**PLANNED UNIT DEVELOPMENT
STAFF REPORT****Date: December 2, 2010****DEVELOPMENT NAME**

Hutchison, Moore, and Rauch LLC

Planned Unit Development Approval to amend a previously approved Planned Unit Development to allow shared access between three building sites.

SITE PLAN

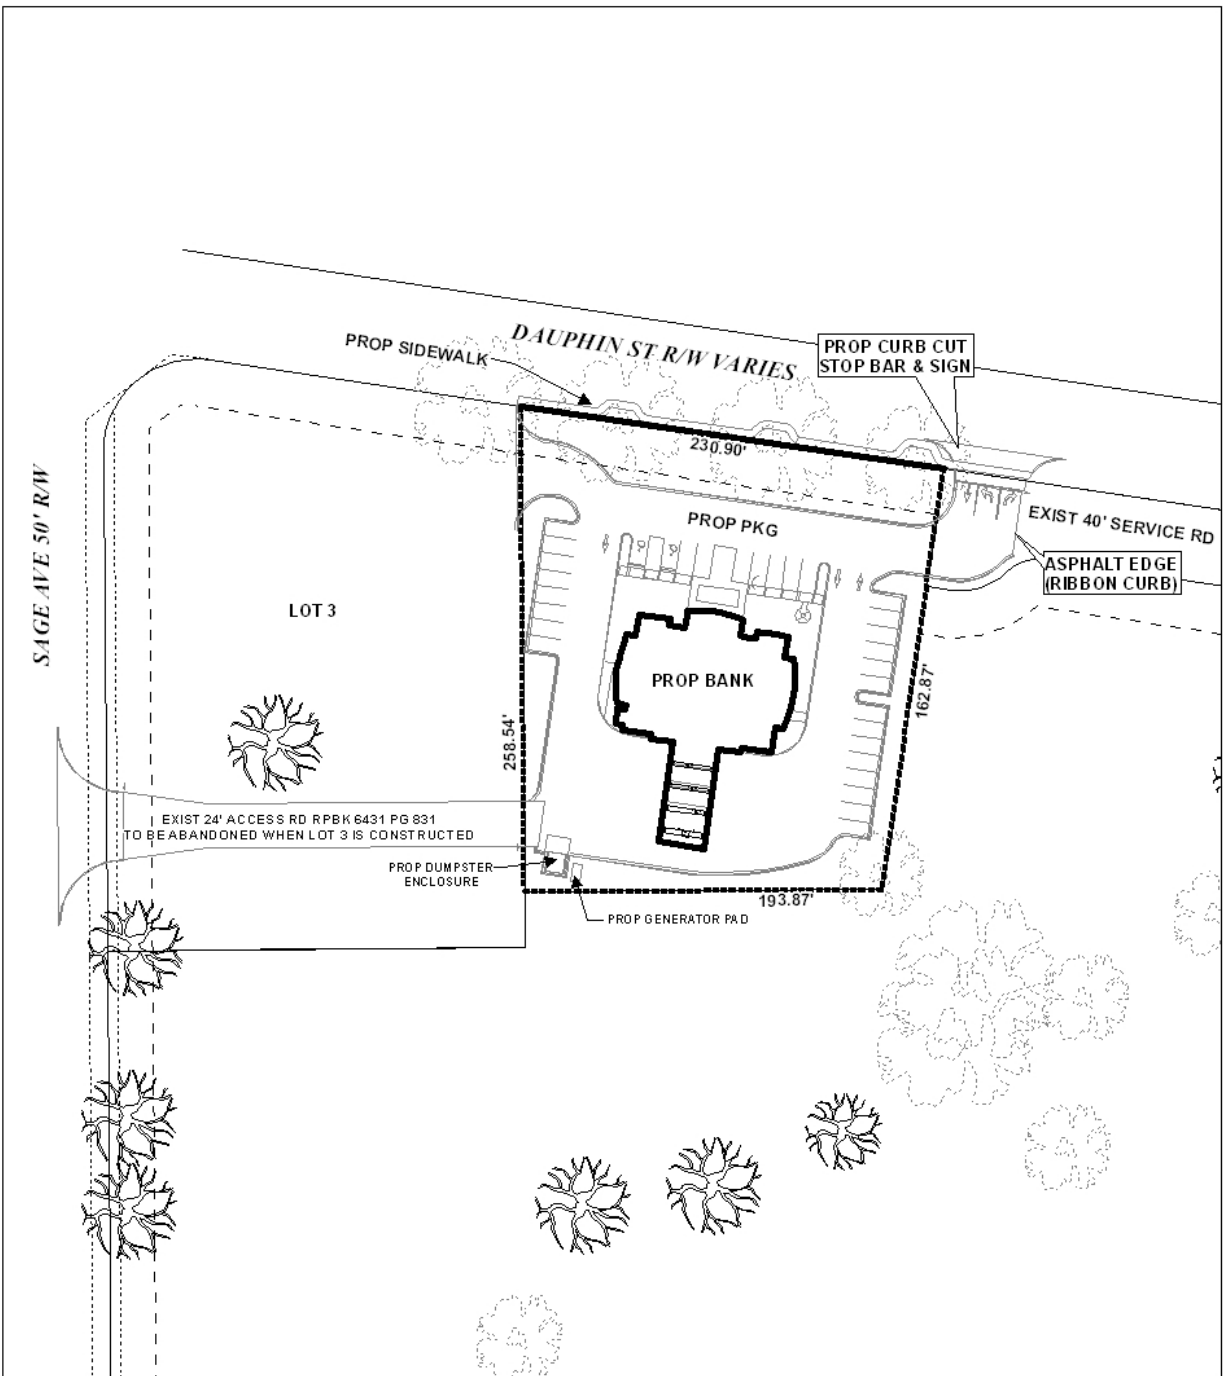
The architectural site plan for the bank site on Lot 2 indicates a total of 31 parking spaces, far in excess of the minimum required. The architectural site plan does not indicate the width of the drive-through lanes, however, the Zoning Ordinance requires a 9-foot curb to curb width, thus

the site plan should be revised to label the width as a minimum of 9-feet. There appears to be adequate stacking room for the drive-through, however, stacking lanes are not depicted.

Information is provided regarding tree compliance, however, no information is provided regarding landscape area compliance. Full compliance with the tree and landscape requirements of the Zoning Ordinance will be necessary.

A sidewalk is depicted along Dauphin Street in front of the proposed bank site. The sidewalk appears to accommodate the existing large live oak trees in the right-of-way. The applicant should review the requirements of the Americans with Disabilities Act regarding connecting commercial sites to adjacent public sidewalks, and revise pedestrian access if necessary.

A generator pad is depicted on the site plan, however, the generator pad will be less than 5 feet from the rear property line. If the generator will exceed 3 feet in height, it must be a minimum of 5 feet from the property line. The adjacent dumpster with enclosure appears to meet the required setbacks.

- 4) Revision of the bank site plan to depict full compliance with the tree and landscape requirements of the Zoning Ordinance;
- 5) Revision of the bank site plan and drive-through design to ensure the provision of 9-foot wide minimum drive-through lanes with stacking areas meeting Zoning Ordinance requirements;

- 6) Revision of the site plan to ensure that any proposed generator or other structure exceeding three feet in height complies with all required setbacks;

- 9) The driveway number, location and size are limited to an approved PUD site plan (one curb-cut to Dauphin Street and one curb-cut to Sage Avenue) subject to Traffic Engineering approval;

- 12) Submission of a revised site plan reflecting these conditions prior to the issuance of any permits; and
- 13) Submission of a new application for PUD approval prior to the development of Lots 1, 3, 4 or 5 beyond the driveways associated with the development on Lot 2.
